Summary of Comments on P:\100\100.061\prelim plan\early grading\100.061early grading cover sheet C0.1 (1)

**PRELIMINARY DRAINAGE PLAN
PUD/SP 20-003**

THE HILLS AT LORSON RANCH

**STORMWATER MANAGEMENT PLAN
FOR THE HILLS AT LORSON RANCH**

Page 5

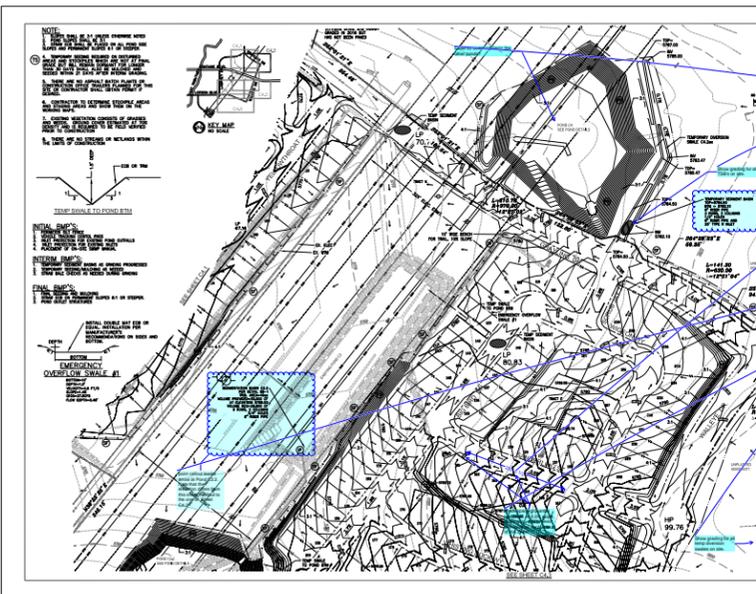
- Author: RSchindler Subject: Sticky Note Date: 10/21/2020 11:25:33 AM
SCHOOL SITE ADDED. NO SCHOOL STRUCTURES ARE WITHIN THIS SITE.
- Author: dotreese Subject: Engineer Date: 8/11/2020 3:41:47 PM
Show easements for all ponds
- Author: RSchindler Subject: Sticky Note Date: 10/21/2020 10:38:57 AM
ON-SITE PONDS ARE BY DRAINAGE TRACTS. WILL INCLUDE OFFSITE EASEMENT FOR POND C4 WITH PLAT
- Author: dotreese Subject: Engineer Date: 8/11/2020 1:19:04 PM
label slope of existing slope
- Author: RSchindler Subject: Sticky Note Date: 10/21/2020 10:38:06 AM
SLOPE LABELED
- Author: dotreese Subject: Cloud+ Date: 8/11/2020 11:51:44 AM
point callout leader arrow at Pond C2.2. Note that the elevation differs from this sheet's callout to the one on Sheet C4.3
- Author: RSchindler Subject: Sticky Note Date: 10/21/2020 11:15:26 AM
TEXT UPDATED

Page: 6

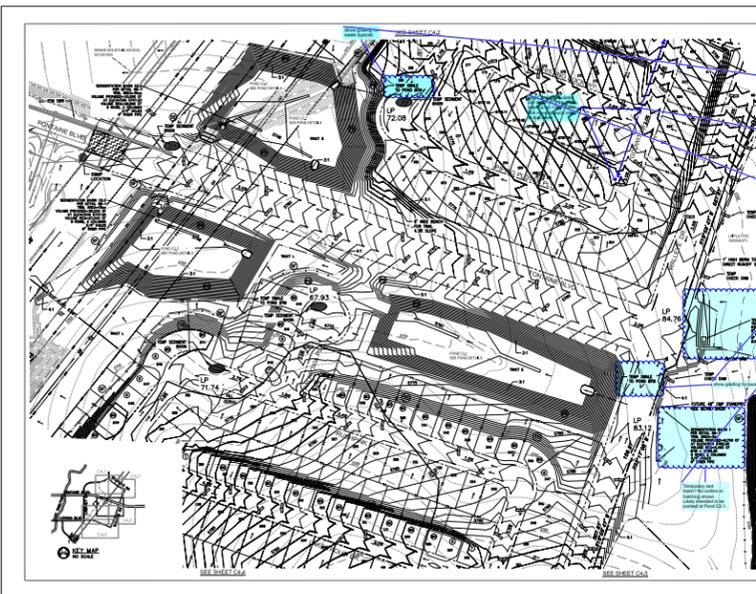
- Author: dotrese Subject: Engineer Date: 8/13/2020 5:25:32 PM
Label as sediment basin like other ponds?
- Author: RSchindler Subject: Sticky Note Date: 10/21/2020 12:54:37 PM
THERE IS NO DISTURBED AREA GOING TO THIS POND AND DOES NOT NEED TO BE A SED. BASIN

- Author: dotrese Subject: Engineer Date: 8/11/2020 3:08:31 PM
Show grading for all TSB's on site.
- Author: RSchindler Subject: Sticky Note Date: 10/21/2020 1:02:48 PM
CHANGED TO SED. TRAPS WITH SIZ.

- Author: dotrese Subject: Cloud+ Date: 8/11/2020 2:49:28 PM
Provide similar details for all other TSB's on site. Include tributary area and design volume (acre-ft) for each

- Author: RSchindler Subject: Sticky Note Date: 10/21/2020 1:03:17 PM
CHANGED TO SED. TRAPS
- Author: dotrese Subject: Dimension Date: 8/11/2020 1:47:37 PM
233'-5 1/2"

- Author: RSchindler Subject: Sticky Note Date: 10/21/2020 12:54:51 PM
ADDED NRE
- Author: dotrese Subject: Cloud+ Date: 8/11/2020 11:51:32 AM
point callout leader arrow at Pond C2.2. Note that the elevation differs from this sheet's callout to the one on Sheet C4.3

- Author: RSchindler Subject: Sticky Note Date: 10/21/2020 11:27:30 AM
TEXT UPDATED
- Author: dotrese Subject: Engineer Date: 9/11/2020 3:11:18 PM
check spacing/quantity per detail. At 3.5% slope, spacing is ~175ft. Need one more on each side of this street

- Author: RSchindler Subject: Sticky Note Date: 10/21/2020 12:24:19 PM
MORE ADDED
- Author: dotrese Subject: Engineer Date: 8/11/2020 3:11:06 PM
Show grading for all temp diversion swales on site.

- Author: RSchindler Subject: Sticky Note Date: 10/21/2020 1:02:32 PM
THERE ARE ONLY TWO DIVERSION SWALES AND ONE BERM. ALL ARE SHOWN. DETAIL EC-10 ADDED

Page: 7

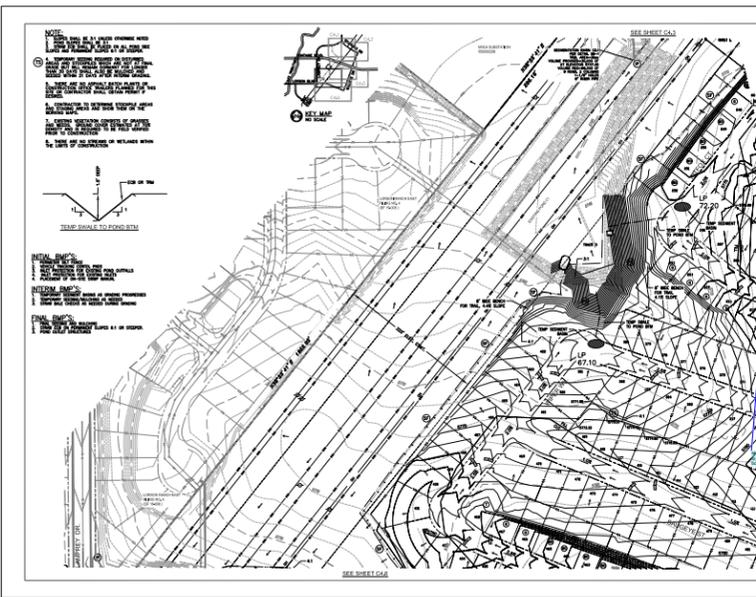
- Author: dotrese Subject: Cloud+ Date: 8/13/2020 5:23:24 PM
 Show grading for swale (typical)
- Author: RSchindler Subject: Sticky Note Date: 10/21/2020 1:03:32 PM
 SWALE REMOVED

- Author: dotrese Subject: Dimension Date: 8/11/2020 1:51:38 PM
 321'-5"
- Author: RSchindler Subject: Sticky Note Date: 10/21/2020 1:03:44 PM
 MORE ADDED

- Author: dotrese Subject: Engineer Date: 8/13/2020 5:10:22 PM
 check spacing/quantity per detail. At 3.5% slope, spacing is ~175ft. Need one more on each side of this street

- Author: RSchindler Subject: Sticky Note Date: 10/21/2020 1:03:40 PM
 MORE ADDED
- Author: dotrese Subject: Cloud+ Date: 8/13/2020 5:10:18 PM
 Show grading and callout sizing details like this for all TSB's (some are just circles with hatching, but no grading/details).

- Author: RSchindler Subject: Sticky Note Date: 10/21/2020 12:13:31 PM
 CHANGED THESE TO SEDIMENT TRAPS. ALL SED. BASINS ARE IN THE PONDS.
- Author: dotrese Subject: Cloud+ Date: 8/13/2020 5:11:29 PM
 show grading for swale

- Author: RSchindler Subject: Sticky Note Date: 10/21/2020 1:04:22 PM
 SWALE REMOVED
- Author: dotrese Subject: Cloud+ Date: 8/13/2020 5:24:59 PM
 Temporary sed basin? No outline or hatching shown. Likely intended to be pointed at Pond C2.1.

- Author: RSchindler Subject: Sticky Note Date: 10/21/2020 1:04:13 PM
 HATCHING ADDED. THIS WAS FOR OFFSITE GRADING AREA

Page: 8

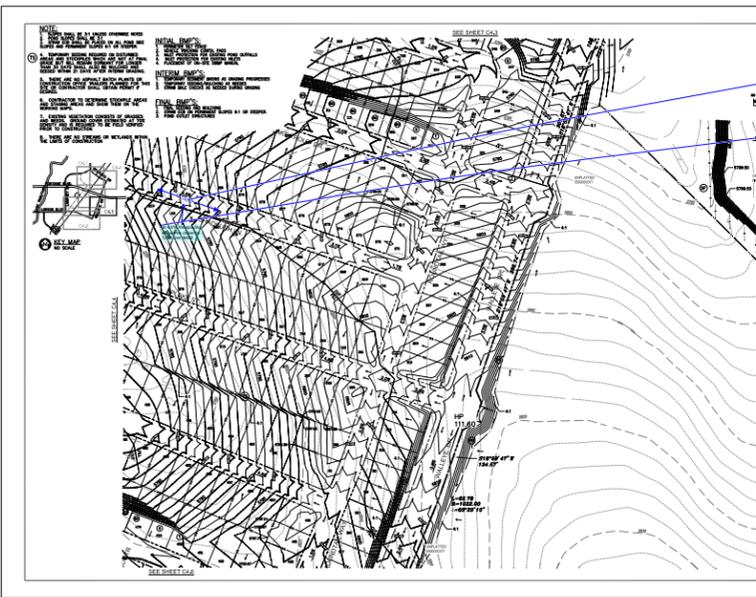
Author: dotresse Subject: Dimension Date: 8/11/2020 1:54:31 PM 163-11.34'

Author: RSchindler Subject: Sticky Note Date: 10/21/2020 12:53:03 PM ADDED MORE

Author: dotresse Subject: Engineer Date: 8/11/2020 1:56:07 PM at 4.8%, spacing needs to be closer to 100ft on both sides of street

Author: RSchindler Subject: Sticky Note Date: 10/21/2020 12:53:08 PM ADDED MORE

Page: 15

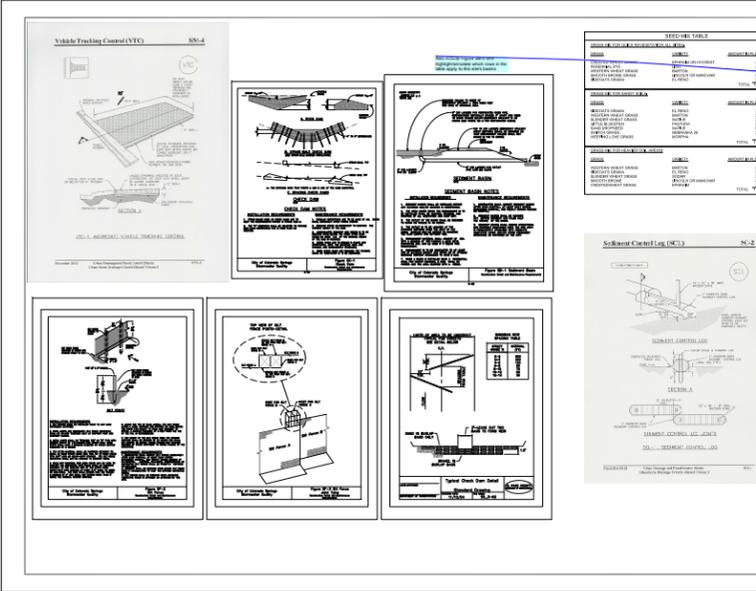
Author: dotresse Subject: Dimension Date: 8/11/2020 1:56:36 PM

140'-7"

Author: RSchindler Subject: Sticky Note Date: 10/21/2020 1:04:39 PM

MORE ADDED

Author: dotresse Subject: Engineer Date: 8/11/2020 1:57:58 PM

at 4.5% the spacing should be closer to 125ft, per detail
